Applicant's Responses to Deadline 7 Submissions

The West Midlands Rail Freight Interchange Order 201X

THE WEST MIDLANDS RAIL FREIGHT INTERCHANGE ORDER 201X
APPLICANT'S RESPONSES TO DEADLINE 7 SUBMISSIONS - DOCUMENT 18.1

RESPONSE TO DEADLINE 7 SUBMISSIONS ABOUT EFFECTS ON GREENSFORGE SAILING CLUB (REP7-035, REP7-066 AND REP7-111)

Figure 1: Local wind directions

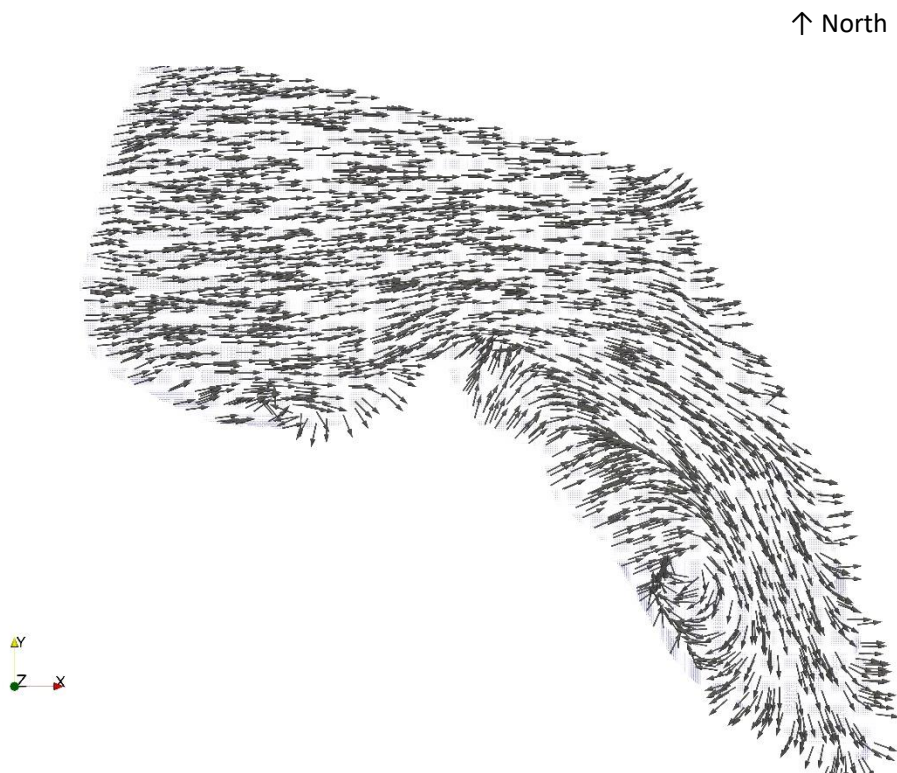
- 2.1 GSC has made comments suggesting that because the Applicant's assessments do not illustrate the wind 'curving' around the reservoir (2.10 in GSC's Deadline 7 response, REP7-035 and pages 1 and 2 of REP7-066) this brings into question the assessments. The Applicant does not concur with this view. As for any robust environmental assessment, there is a need to follow a recognised approach, which the Computational Fluid Dynamic (CFD) modelling has provided.

- 2.2 The Figures presented in the RWDI (REP4-013) and Wolfson Unit study (REP4-012) show wind speed intensity, not direction (which was potentially misunderstood by GSC). The applicant can't verify the data provided by GSC, however the applicant's advisors have further considered the points raised by GSC and **Figure 1**, below, illustrates local wind angles of the data used by RWDI for the existing site at a nominal wind angle of 270 degrees and 3-metre measurement height. Figure 1 is based on the existing CFD model data and in general terms this shows the wind 'curving' around the reservoir in a similar manner to the anecdotal evidence provided by GSC.

- 2.3 The base CFD results underlying the analysis by RWDI are in general terms predicting what is being perceived on the reservoir by the users (from a qualitative comparison), reinforcing the validity of the data and subsequent approaches.

4.4 The applicant considers that GSC haven't proposed viable methods of assessment as alternatives to the assessments undertaken by the applicant. The assessments undertaken by the Applicant follow a recognised methodology and in fact as illustrated in Figure 1 above the findings aren't inconsistent with GSC's experience.
